BELLOWS ADDITION

RE: SUB 2000-51 -- One-Step Final Plat of BELLOWS ADDITION

CASE NUMBER: SUB 2000-51 -- BELLOWS ADDITION

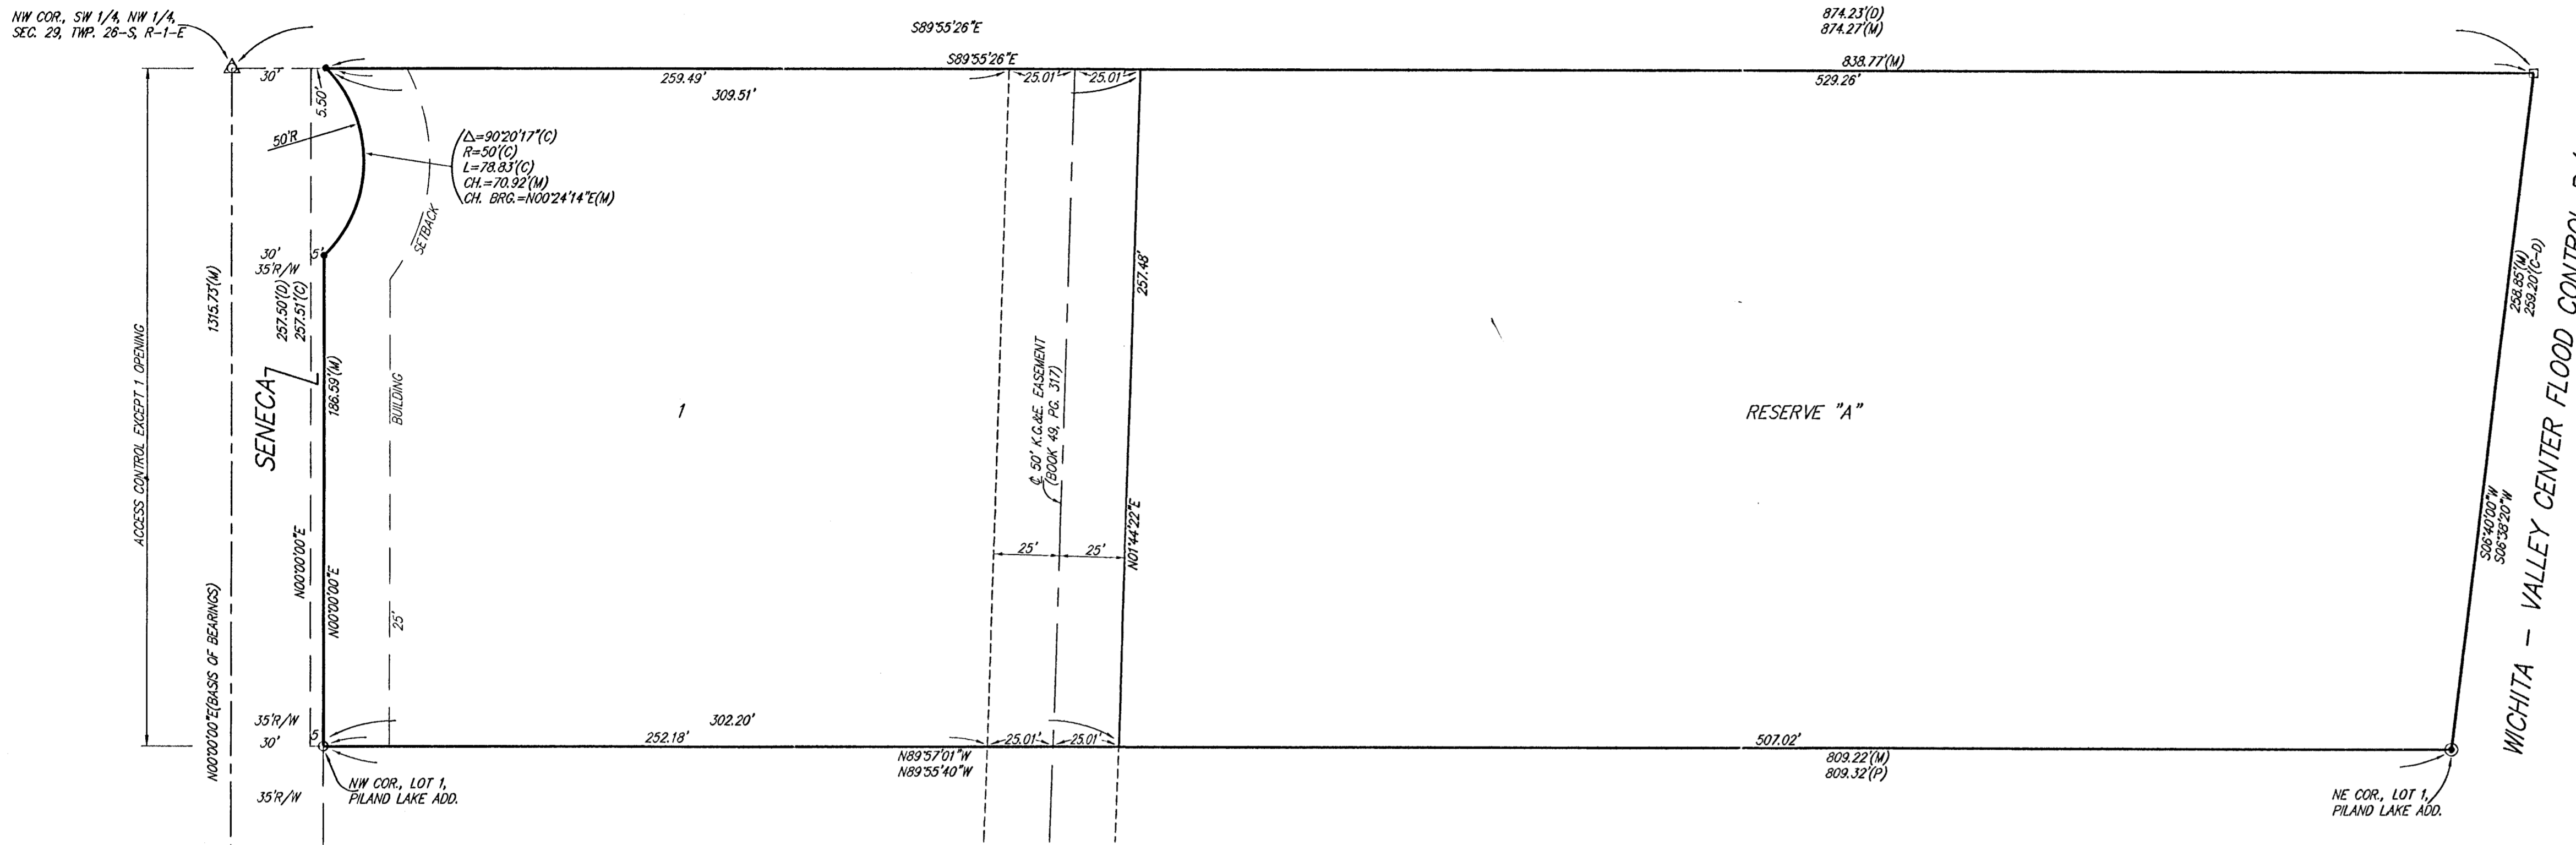
- A. Since neither municipal water nor sanitary sewer is available to serve this property, the applicant shall contact the Environmental Health Division of the Health Department to find out what tests may be necessary and what standards are to be met for approval of on-site sewerage facilities and water wells. A memorandum shall be obtained specifying approval. Standard soil testing is approved.

- B. City Engineering needs to indicate the status of Wichita water and sewer services for this area and if petitions for future extensions need to be provided at this time. A petition for future extension of sanitary sewer and public water is required.

- D. City Engineering needs to comment on the status of the applicant's drainage plan and the need for the platting of a Floodway Reserve for the existing lake. A Floodway Reserve should be platted for the eastern portion of the property.

- E. Traffic Engineering needs to comment on the need for access controls. The final plat tracing shall reference the access controls in the platlor's text. Traffic Engineering has approved access control except for one opening along Seneca.

- G. Due to the excessive lot depth, City Fire Department needs to comment on the need for a maximum building setback to accommodate fire prevention equipment. *The plat shall include a Floodway Reserve along the eastern portion which would limit construction.*

- H. The lot depth to width ratio exceeds 2.5 to 1 and a modification from the Subdivision Committee will be required. *A modification is approved.*
- I. The 50-foot KG&E easement needs sufficient ties to locate it definitely with respect to the subdivision.

- J. The plat's text shall include language that a drainage plan has been developed for the plat and that all drainage easements, rights-of-way, or reserves shall remain at established grades or as modified with the approval of the applicable City or County Engineer, and unobstructed to allow for the conveyance of stormwater.
